ECE/TRANS/WP.29/GRE/2004/5/Rev.2 */
19 January 2006

REVISED PROPOSAL FOR DRAFT AMENDMENTS TO REGULATIONS Nos. 48 and 87

Transmitted by the expert from the Working Party "Brussels 1952" (GTB)

REGULATION No. 87 – (Daytime running lamps)

Annex 3, paragraph 5., amend the table of standard light distribution to read:

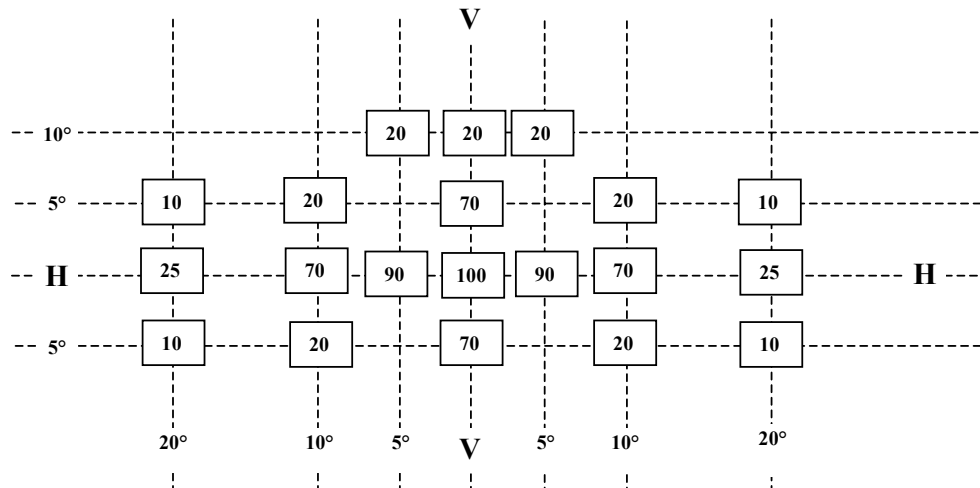
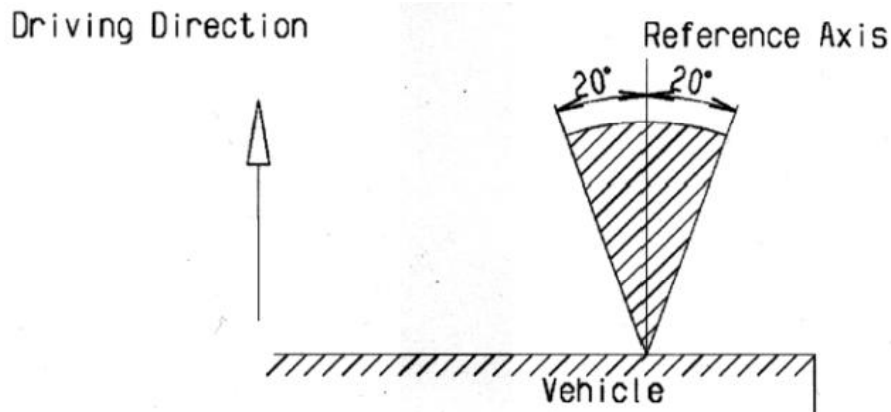
The standard light distribution in Annex 3 of Regulation No. 87 has been modified to restrict the requirements to 5 degrees down. This is because a DRL is intended to give advanced warning of the presence or approach of a vehicle and there is unlikely to be a case where the viewing angle will be below 5 degrees down.

The current photometric table requires the beam to extend to 10 degrees down, but to achieve this it is necessary to divert useful flux from the effective areas.
